July 15, 2015

**Re: Promulgation of Air Quality Implementation Plans; State of Arkansas;
Regional Haze and Interstate Visibility Transport Federal Implementation Plan;
Docket No. EPA-R06-OAR-2015-0189**

State Implementation Plan Review for the Five-Year Regional Haze Progress Report

**Figure 1 Reasonable Progress Assessment Upper Buffalo Wilderness Area,
Arkansas 20% Worst Days**

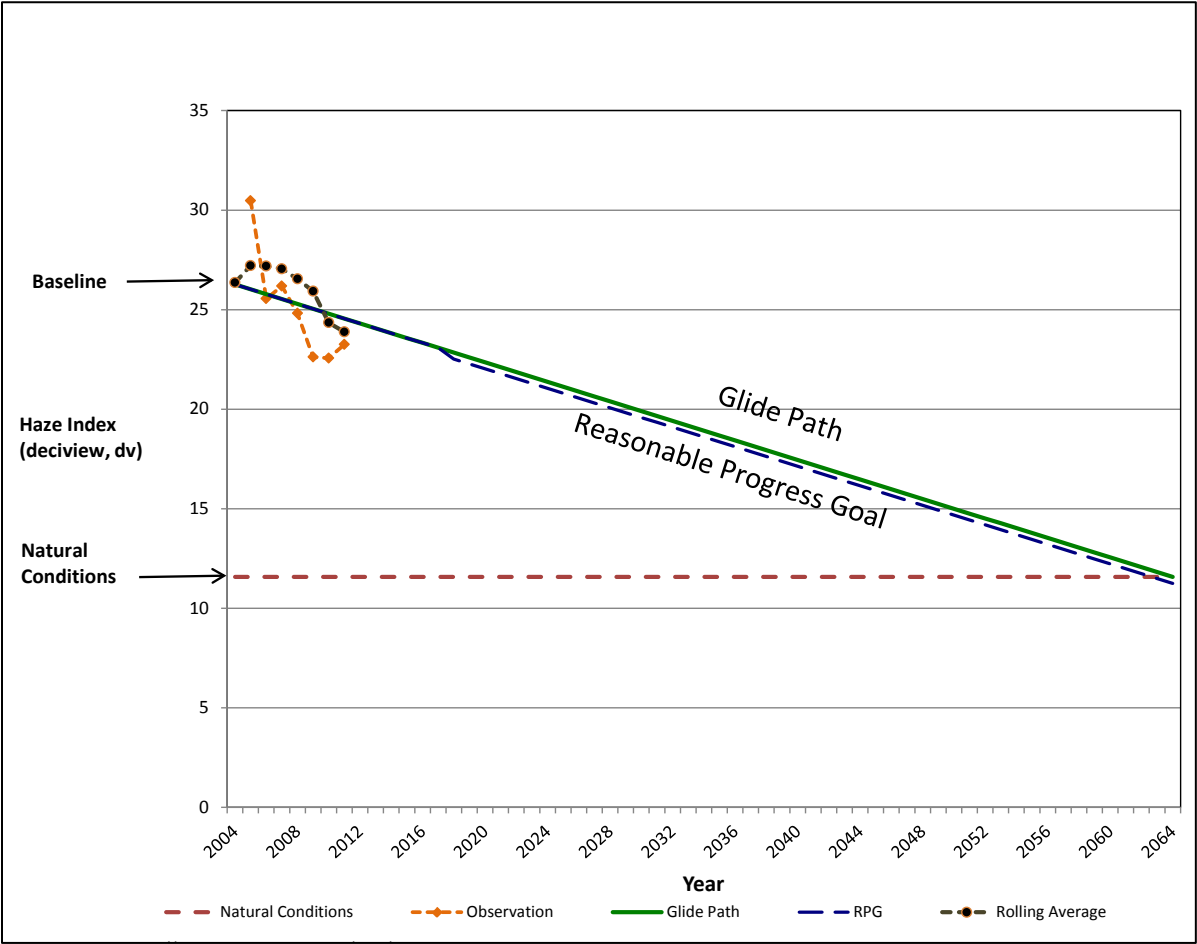
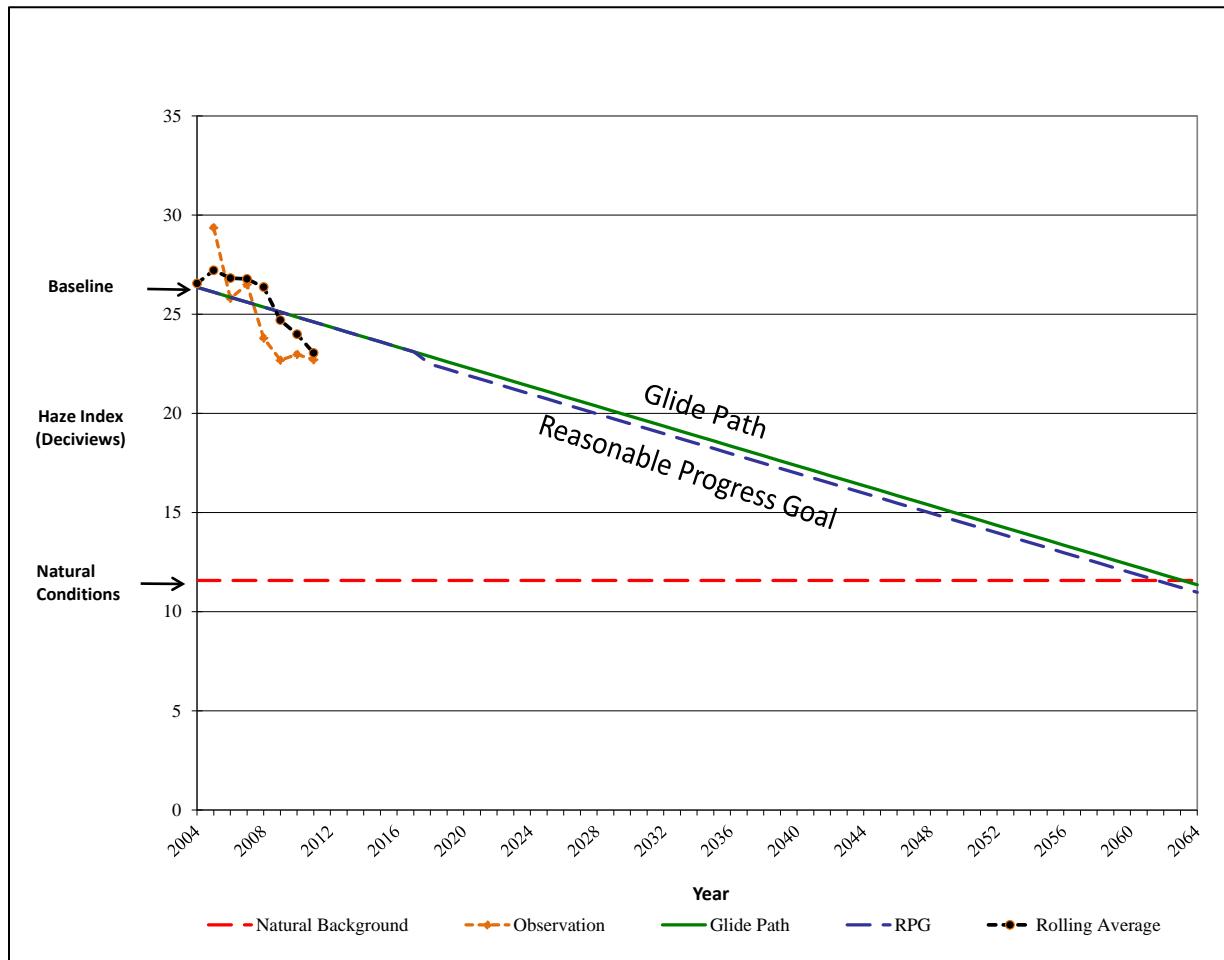
As pointed out in the Five-Year Progress Report State SIP revision, Arkansas is making substantial progress in addressing regional haze in its Class I areas and is on schedule to meet its own proposed RPGs and the URP for the first planning period.⁶⁷ This means that Arkansas is well on track to reaching background visibility conditions by 2064. Despite this progress, EPA proposed RPGs that are more aggressive than that necessary to achieve the program's goal, which is inconsistent with surrounding states that have wide-ranging RPGs placing them on a path to achieve background visibility conditions well beyond 2064.

Despite Arkansas being on schedule to meet or beat the trajectory needed to achieve background visibility conditions by 2064, EPA is proposing more stringent RPGs that would require unnecessary additional controls. Specifically, EPA is requiring additional controls on Entergy Independence Units 1 and 2.⁷³ EPA’s proposed RPGs are more aggressive, which is inconsistent with EPA’s approach in certain other states that allow RPGs that would improve visibility over a much longer timeframe.⁷⁴

Figure 2.1. Percent Contribution of Major Haze Components to 20% Worst Days at Caney Creek Wilderness Area, Arkansas, for the Current Five-Year Average (2007-2011)

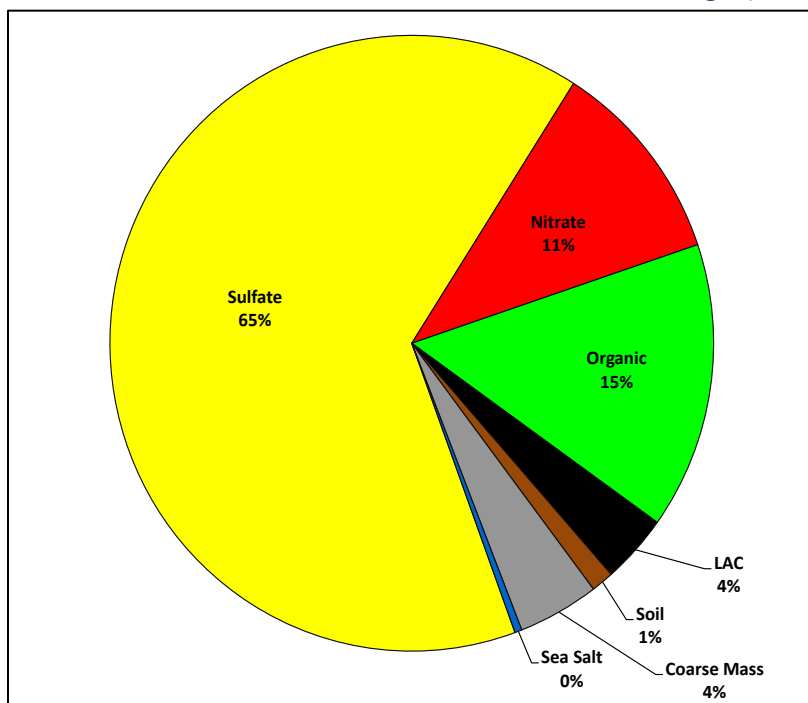
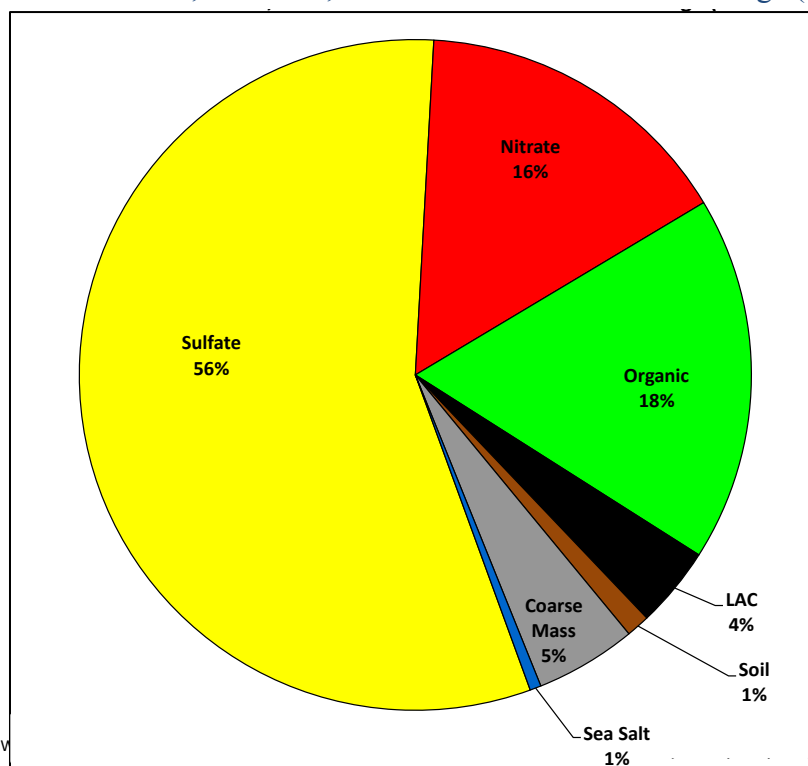
Chapter 2.1: The description of pollutant contributions to haze on the 20% worst days at Caney Creek and Upper Buffalo Wilderness Areas (WAs) is good. Figures 2.1 and 2.2 demonstrate that sulfate is the largest contributor to haze of the 20% worst days. Figure 2.3 demonstrates that Electric Generating Units (EGU) and non-EGU point sources are the largest contributors to sulfur dioxide (SO₂) emissions in Arkansas. Therefore we would expect Arkansas to concentrate on reducing point source SO₂ emissions in the long-term strategy.

Comment 1: In Chapter 2.1, the description of pollutant contributions to haze on the 20% worst days at Caney Creek and Upper Buffalo Wilderness Areas is good. Figures 2.1 and 2.2 demonstrate that sulfate is the largest contributor to haze of the 20% worst days. Figure 2.3 demonstrates that Electric Generating Units (EGU) and non-EGU point sources are the largest contributors to sulfur dioxide (SO₂) emissions in Arkansas. Therefore, NPS would expect Arkansas to concentrate on reducing point source SO₂ emissions in the long-term strategy.
